DEPARTMENT OF HIGHWAYS-ONTARIO  
BRIDGE OFFICE-TORONTO

EASTCROSS CREEK BRIDGE  
(CADMUS CREEK)

FOUNDATION INVESTIGATION -- by  
E. M. Peto Associates, Ltd.

Re: East Cross Creek Bridge, Highway 7-A,  
Township of Cartwright, District No.7,  
W.P. 42-60.

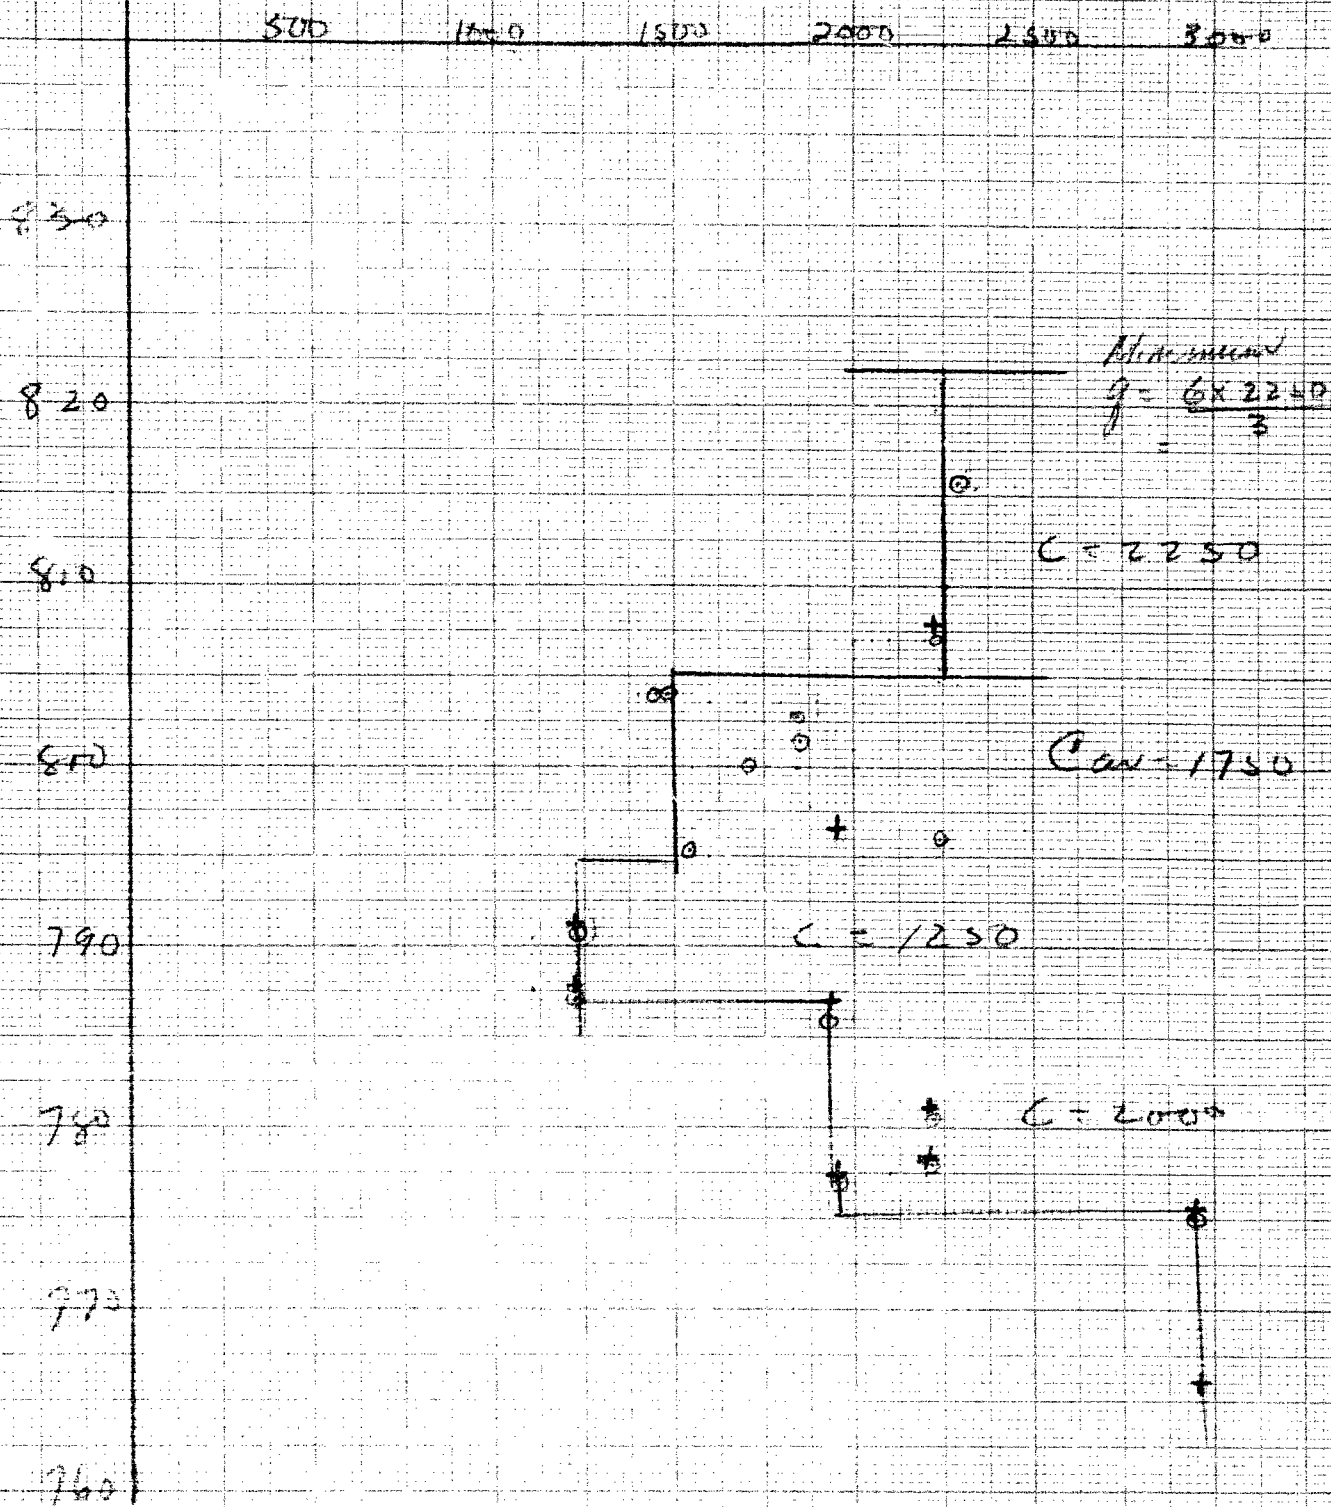
Bridge is located less than half way ~~between~~ to Hwy/35 from Junction to Casarrea. Work must continue on West side. Expect to find rock along - via which over sand. The centre holes are to check substantial settlement and stability. Rock coring will only be carried on depending on condition of overburden in respect of foundation bearing and settlement characteristics. Dutch Cone to be driven before each hole. If soft clays are found the shear strength profile must be determined by Vane Test as well as Laboratory Test on undisturbed samples. Then 4" casing will be required for both Vane Test and Consolidation samples.

Holes # 1 & 6 for bank stability.

Hole # 2 to confirm conditions at # 3

Hole # 4 to confirm conditions at Hole # 1

# SHEAR STRENGTH VS. ELEVATION.

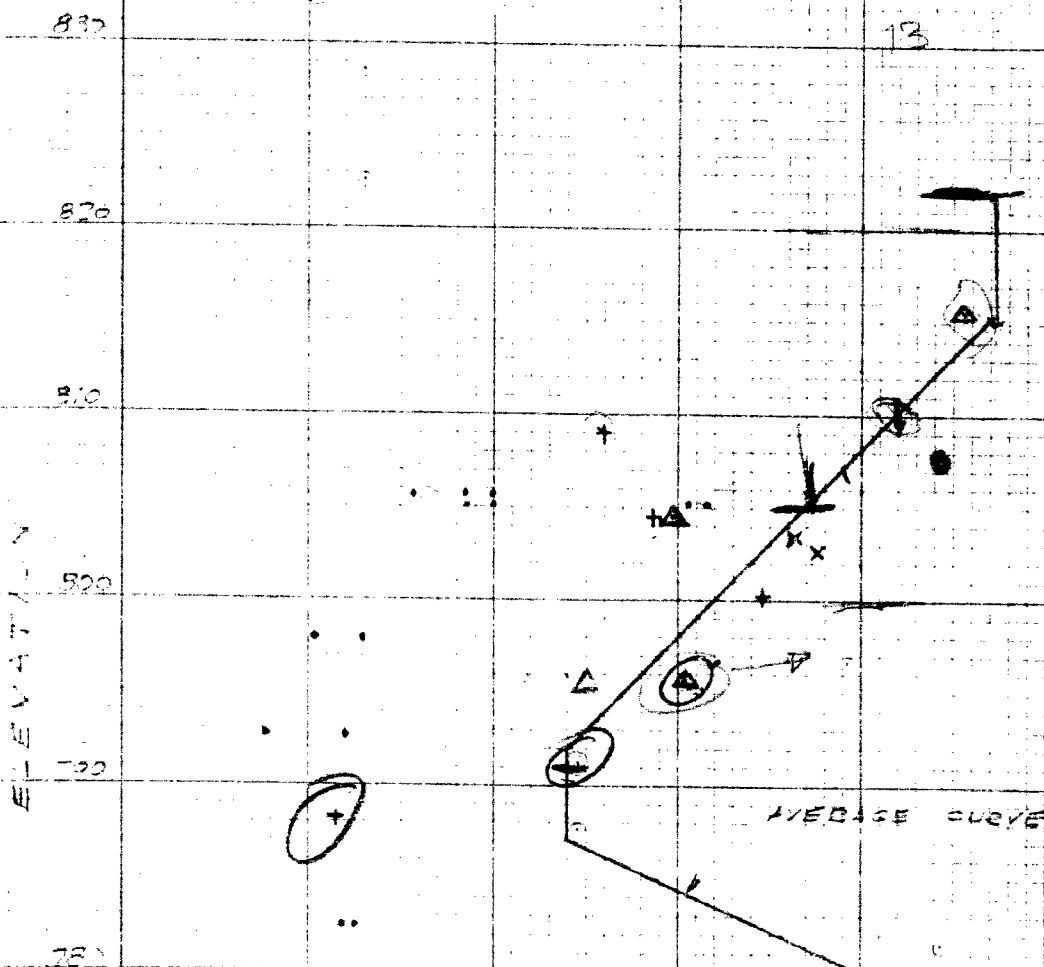
On the graph of shear strength versus elevation (Part I, Appendix III) an attempt was made to find the best shear strength distribution between the shear values as obtained from various tests. A line was drawn indicating the assumed average undrained shear strength distribution with depth. This curve gives the following  $S_u$  values (as given in the report)

The interpretation of shear strength values is not correct because of

There was a difference of opinion in the choice of the shear strength value for the calculation of the bearing value at the proposed footing elevation. We had no criticism to make of Mr. Soderman's choice of shear strength of 2250 lbs./sq. ft. compared with the 2100 lbs./sq. ft. given in our report. The reason we chose the lower figure was because we felt that this figure was substantiated by a greater number of results at the lower elevation. It was quite true that no actual shear value was available at the proposed footing elevation, but the assumption was made that it could not be lower than 2100 lbs./sq. ft.
